Reference: Cambridge Crossing Parcel H Design Review Revision
Cambridge Crossing Parcel G Design Review Revision
Request for Minor Amendment
PB #179
Cambridge, Massachusetts

DESIGN REVIEW REVISION

BUILDING G AND BUILDING H PEDESTRIAN BRIDGE - CDD STAFF MEETING COMMENTS FROM VIRTUAL MEETING ON MAY 24, 2021

ADDITIONAL GFA FROM BRIDGES

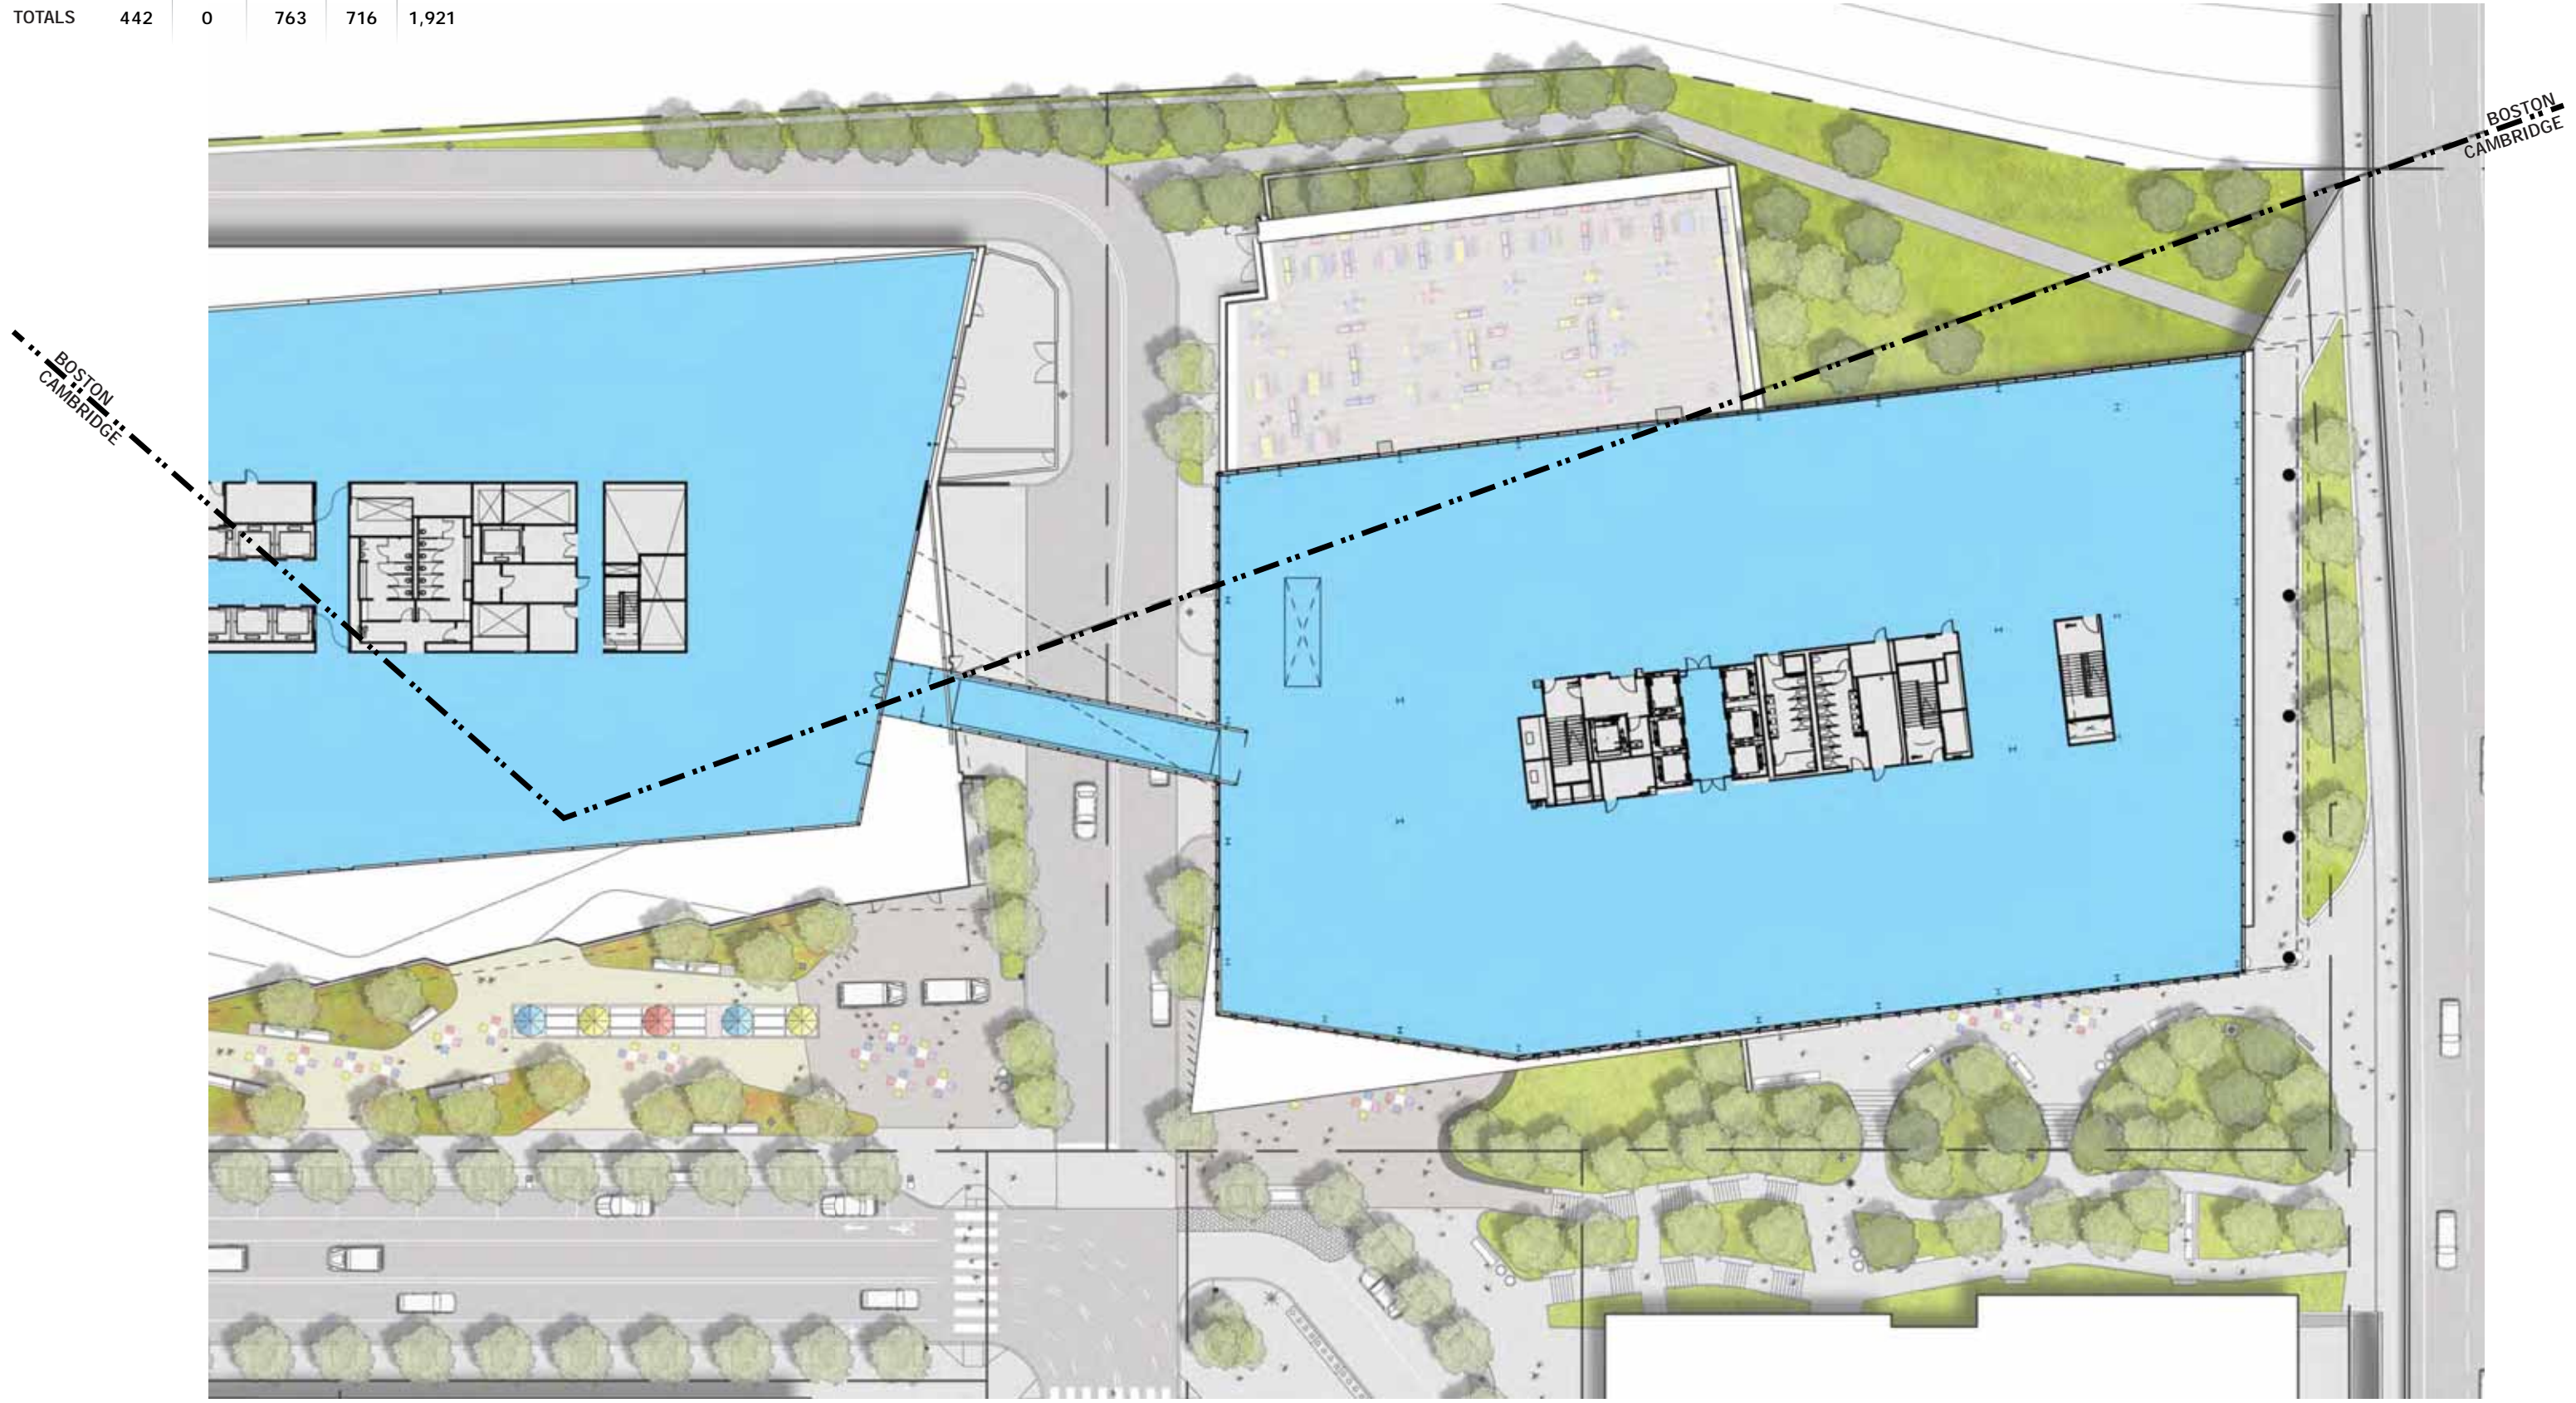
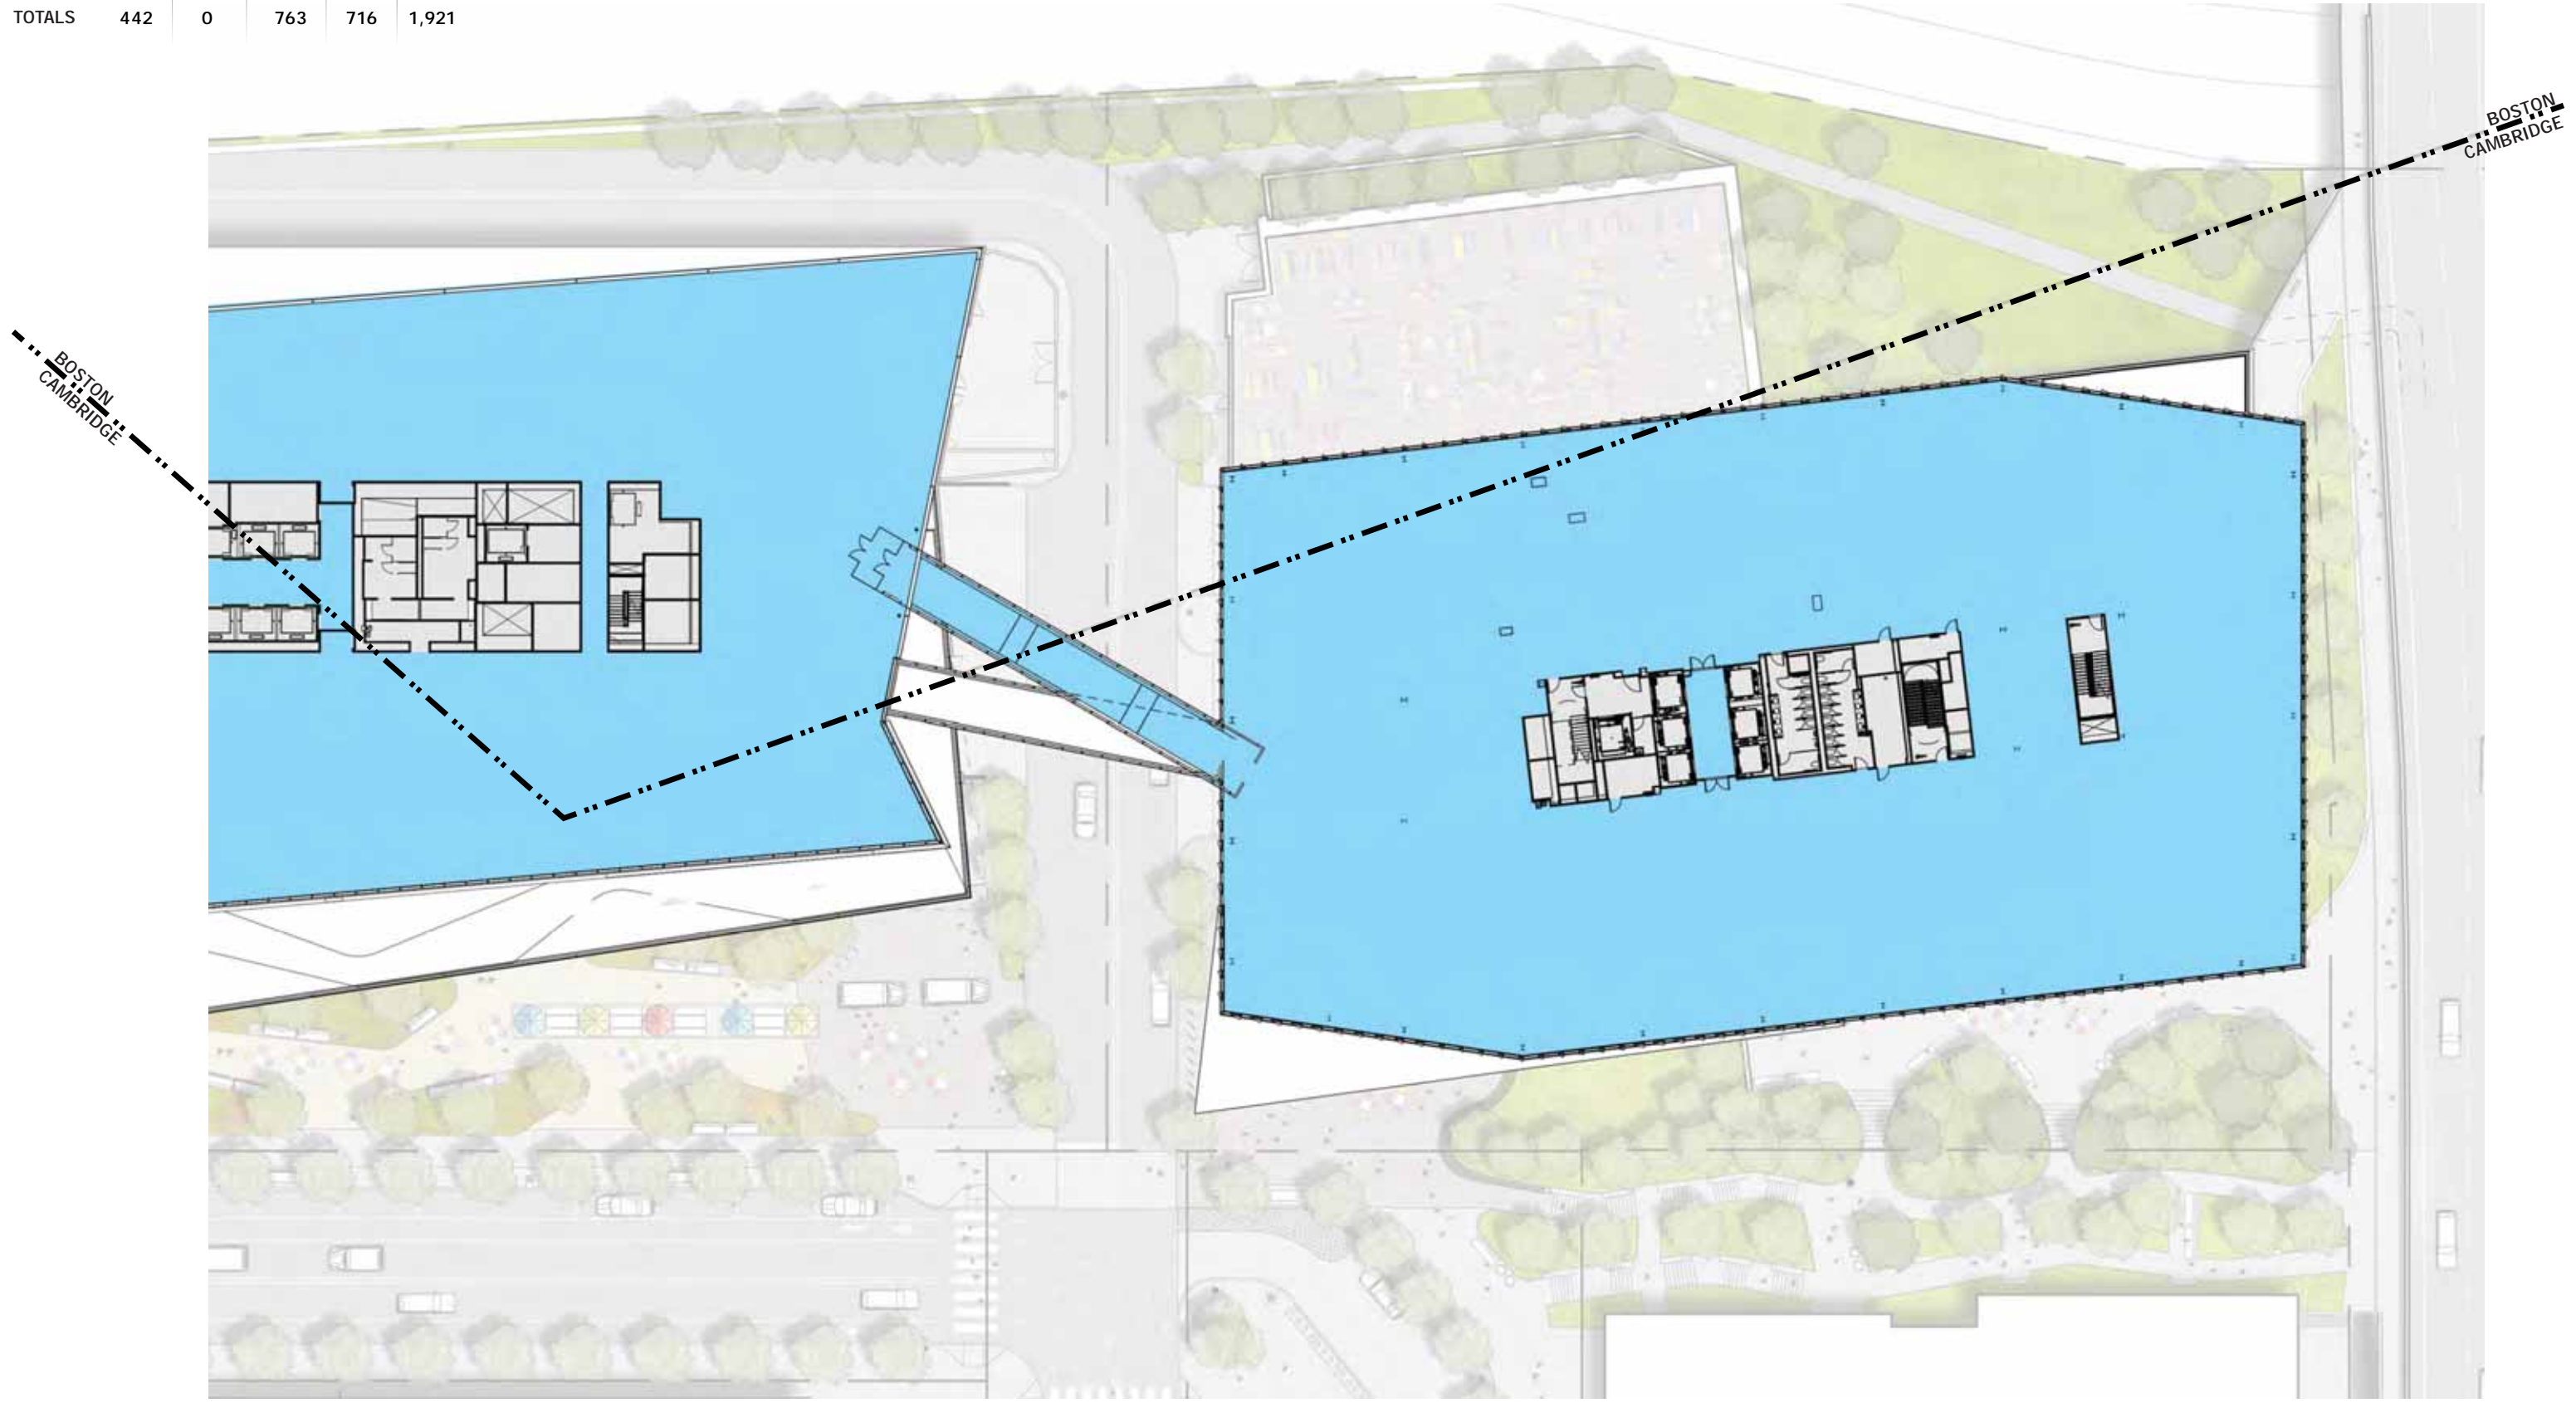
COMMENT	RESPONSE	PAGE REF	CLOSED
<i>GENERAL</i>			
1. <i>Is a minor amendment required for the additional floor area associated with the bridges?</i>	Yes - The Gross Floor Area (GFA) of the bridges within Lot G exceed the maximum GFA allocated for Lot G by more than 10% of the approved figure. Approval of the pedestrian bridges would be conditional with approval of Minor Amendment #9 for the increased GFA approved on Lot G.	39-42	Yes

2. <i>If a minor amendment is required, the Appendix I will need to be updated to reflect the reduction of commercial GFA on other parcels.</i>	Yes - An updated Appendix I has been submitted which contemplates the approval of the pedestrian bridges and reductions to commercial GFA allocated to future commercial development lots.	39-42	Yes

BOSTON		CAMBRIDGE		TOTAL BY LEVEL
	G	H	G	H	
LEVEL 3	72	0	541	342	955
LEVEL 9	370	0	222	374	966
TOTALS	442	0	763	716	1,921
